**Memorandum – Coastal Engineering Review
Review of USACE Proposed Mitigation for Impacts Rockaway
Peninsula Storm Risk Reduction on Sediment Transport to GATE JBU
Atlantic Beaches
TAR 19876**

13 October 2021

GATE - Coastal Engineering Review of Rockaway Peninsula storm damage reduction

Figure 1 - Proposed Section of Reinforced Dune from Rockaway C2 Revised Post Review 2021-04-15.pdf

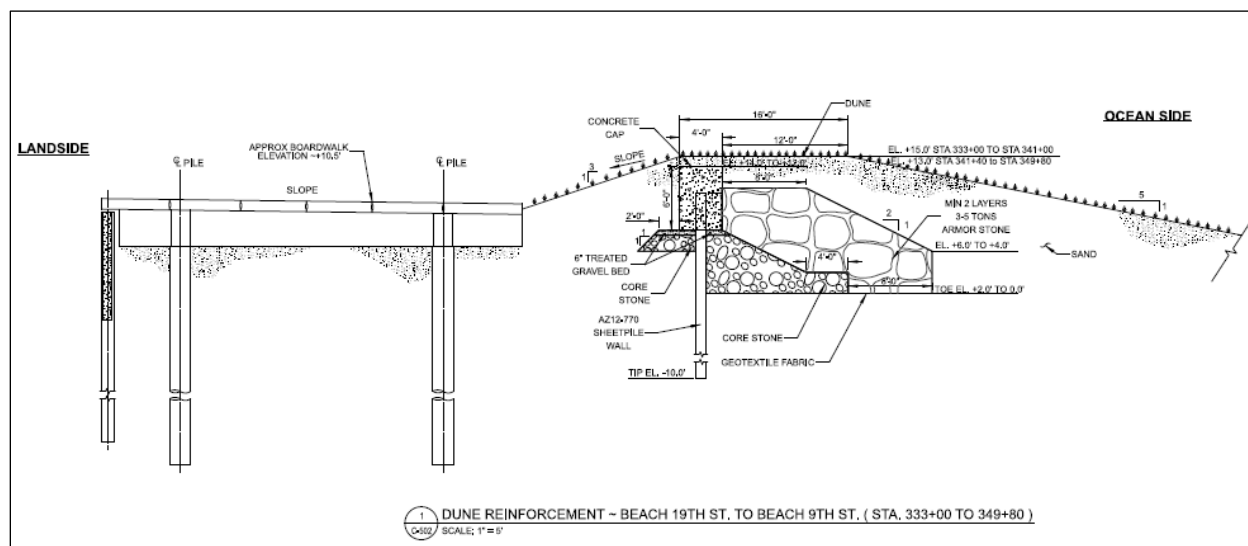
The design of the reinforced dune system is based on the installation of a sheet pile floodwall with concrete cap, which is covered by a natural dune. The dune is designed to resist flood forces from the revised FEMA and ASCE standards New York City adopted post-Sandy, while the buried sheet pile floodwall will prevent any transmission of floodwaters through the dune during prolonged storm surge events, typically associated with hurricanes or large nor'easters (refer to Figure 1). This design has been vetted through the RBD review process, including numerous public meetings and comment, and is focused on preventing flood damage rather than modifying sediment transport at the site. While the continued nourishment of the dune system will provide significant source material for sediment transport, the reinforced dune project is not likely to significantly impact sediment transport rates laterally along the shoreline as there are no structures that will allow for an increase or decrease in sediment movement.

Figure 2 - Local Model Grid from Attachment 1-Rockaway_CMS_final (1).pdf

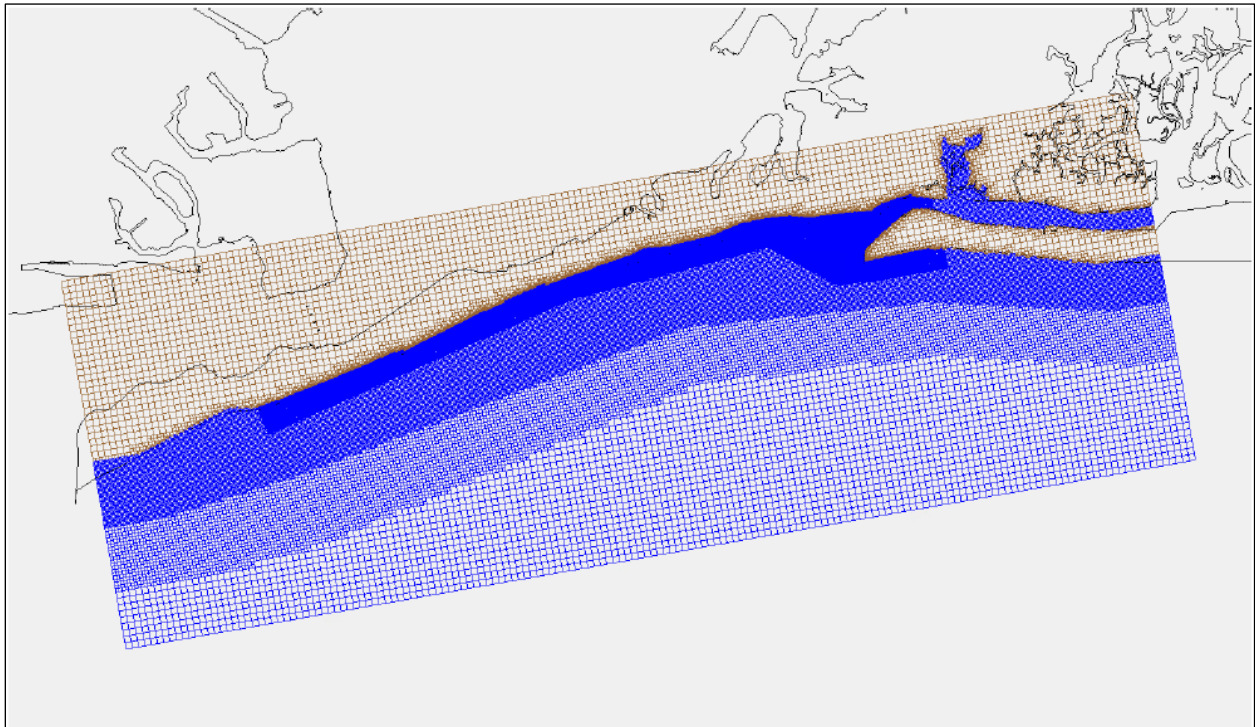
CMS-Flow is the typical numerical model suite used by USACE for sediment transport analysis. This model relies on rectilinear grids to depict the model domain, with squares ranging from 4 to 256 meters used for the local level model of the project area (Figure 2). This resolution is considered coarse to analyze near-field impacts, as the smallest feature that would typically be captured is 2 grid cells, or 8 meters across. It should also be noted that the grid sizing chosen makes it problematic to model the

existing groins located along Jacob Riis Park as they vary in size from 1-3 meters wide as measured from existing aerial photography by the EA review team. The project area is the southern shore of the Rockaways on Long Island, appearing as solid blue due to the scale of Figure 2. The western and southern boundaries are within the Atlantic Ocean, along with most of the eastern boundary.

A small portion of the eastern boundary is located within Jamaica Bay, where the model has been simplified by assuming a large portion of the bay to be dry land (brown squares in Figure 2). The simplification of Jamaica Bay may be accomplished by defining an input at the small connection with Jamaica Bay and extracting the information from the larger regional model and using that for an input at this location. It is unclear if this approach was followed as the input locations are not identified in the report. The report states that all “open boundary” locations were forced using the larger regional model.

Figure 3 - Tidal Velocity Model Agreement to observed data from Attachment 1-Rockaway_CMS_final (1).pdf

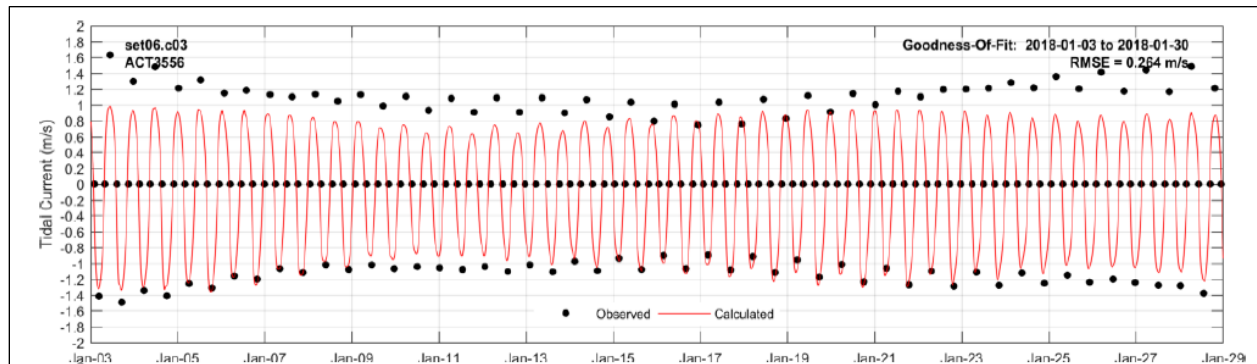
The inlet to Jamaica Bay is the closest area where velocity gage data was available for the months of January and June in 2018, which were used as the validation periods. As Figure 3 shows, the model consistently underpredicts observed flood tidal currents during this event, with better agreement to ebb currents, compared to the flood currents. No discussion is made on why these two months from 2018 were chosen, or of any significant storm events that may have occurred during these months. An internet search indicates a significant “bomb cyclone” that occurred in January of 2018 causing higher than average waves and winds to hit the Rockaways (https://www.wpc.ncep.noaa.gov/storm_summaries/2018/storm1/stormsum_6.html).

Figure 4 - Measured vs Modelled Sedimentation from Attachment 1-Rockaway_CMS_final (1).pdf

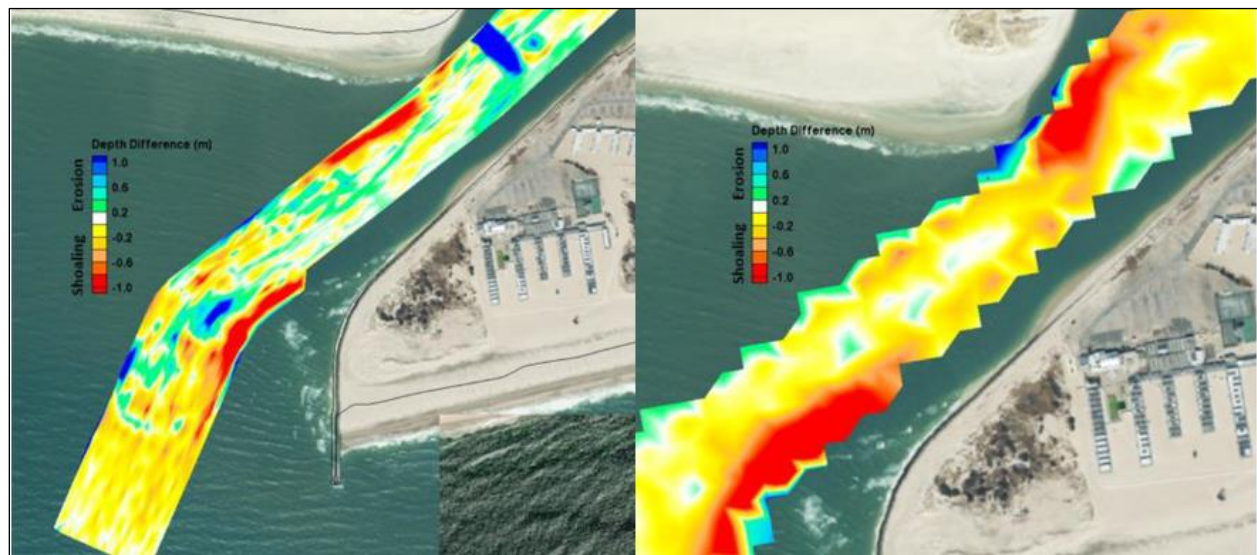
The sediment transport model was calibrated using two surveys (February and March 2017) with no dredging operations taking place between them. A comparison of the differences between the two surveys and the modelled differences using the first survey to start the model can be seen in Figure 4. These two images from the modeling report are shown side-by-side for ease of comparison, and the different views are taken from the original report. These show some similarities within the area modelled, but the overall patterns appear to be substantially different.
